Docket No. 52-048

**SUBJECT:** NuScale Power, LLC Response to NRC Request for Additional Information No. 03 (eRAI No. 8744) on the NuScale Design Certification Application

**REFERENCE:** U.S. Nuclear Regulatory Commission, "Request for Additional Information No. 03 (eRAI No. 8744)," dated April 25, 2017

Enclosure 1: NuScale Response to NRC Request for Additional Information eRAI No. 8744

Figure 15.2-44: Hot Channel Node MCHFR - ~~Peak RCS Pressure~~ Limiting MCHFR Case (15.2.8 Feedwater Line Break)

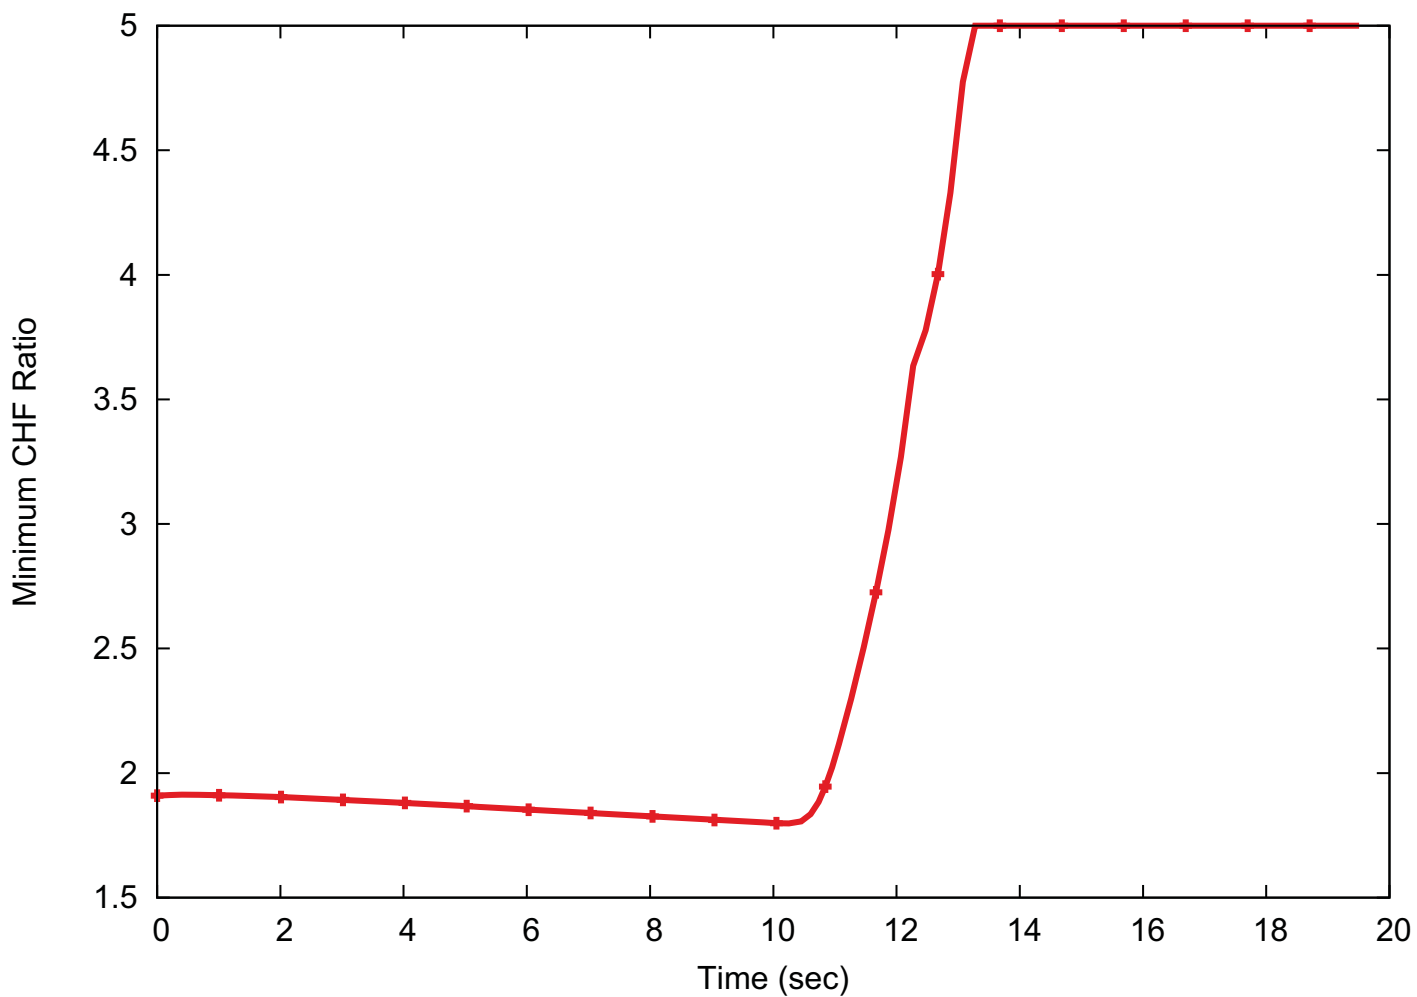
In Final Safety Analysis Report (FSAR) Tier 2, Section 15.2.8.4, "Input Parameters and Initial Conditions," the applicant states that a 30% uncertainty is added to the steam generator heat transfer. However, in FSAR Tier 2, Table 15.2-28, "Biases and Uncertainties - Feedwater Line Break," the applicant states that a -30% uncertainty is used for the steam generator heat transfer. The staff notes that these statements in the FSAR are inconsistent. Based on the docketed information, the staff is unable to determine what uncertainty value is used for the steam generator heat transfer and the adequacy of the reported 30% uncertainty addition to the steam generator heat transfer. The staff requests the applicant to clearly state in the FSAR which uncertainty value is used and provide justification in the FSAR as to why the applicant adds to (or subtracts from) the steam generator heat transfer.

FSAR Sections 15.2.8.2, 15.2.8.4, 15.2.8.5, and FSAR Figure 15.2-44 have been revised as described in the response above and as shown in the markups provided in this response.

In the course of preparing this response, NuScale has included some editorial corrections and clarifications in the attached FSAR markup. In FSAR Section 15.2.8.2, an incorrect characterization of the limiting MCHFR case was eliminated. In FSAR Section 15.2.8.4, the term "Case A" was deleted because it refers to an internal calculation reference. Additionally, wording was added to clarify that the FWIV backflow prevention device is the safety-related FW check valve. The description of the limiting SG pressure event was also corrected to indicate that AC power is lost at the time of the break. In FSAR Section 15.2.8.5, a statement was added to clarify that the high pressurizer pressure reactor trip is delayed by biasing pressurizer pressure and level low.

In the limiting MCHFR case, the high pressurizer pressure trip is delayed, by biasing pressurizer pressure and level low, resulting in higher temperatures and the MCHFR occurs right before the reactor trips. The MCHFR versus time is presented on Figure 15.2-44.
